Report: TAB Report
Function: Test, Adjust, & Balance
Date: 11/11/2025
Completed By: National TAB

08-25-25 WAWA #7206 COLERAIN, OH

Section	Page #
Summary	3
Remarks	4
Balance Schedule	8
Checklist Data	9
AHU/RTU	19
FAN - Exhaust	28
GRD Layout	35

Project Issue Information

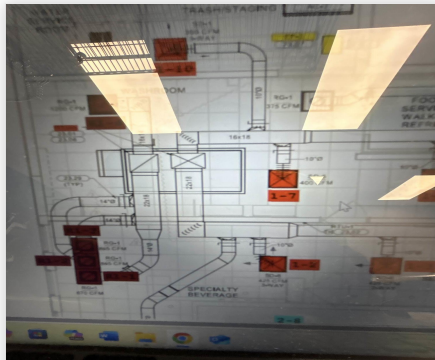
Issue Name : RTU 1 Diffuser 7 Low Flow
Description : Rtu 1 diffuser 7 low on airflow. When other diffusers airflow were reduced the airflow at diffuser 7 remained unchanged. Takeoff for diffuser 7 is close to an 90 degree turn. This may be preventing air from getting to diffuser 7. Other diffusers reopened to keep airflow total at design.
Created By : National TAB **Assigned To :** National TAB - Will Turnbough
Status : Open
Priority : Low **Asset Tag :**
Originated Date : 08/26/2025 - Gabe Merk - National TAB

- **08/28/2025 National TAB - Gabe Merk**
 - This will not be resolved without redesigning the takeoff for this unit.

Project Issue Information

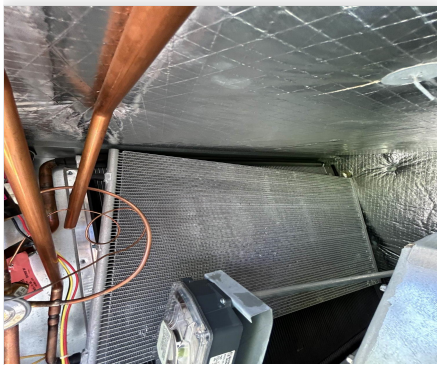
Issue Name : RTU 3 Reheat Coil
Description : Rtu 3 reheat coil improperly installed. This may lead to refrigerant leaks in the future.
Created By : National TAB **Assigned To :** National TAB - Will Turnbough
Status : Open
Priority : Low **Asset Tag :**
Originated Date : 08/26/2025 - Gabe Merk - National TAB
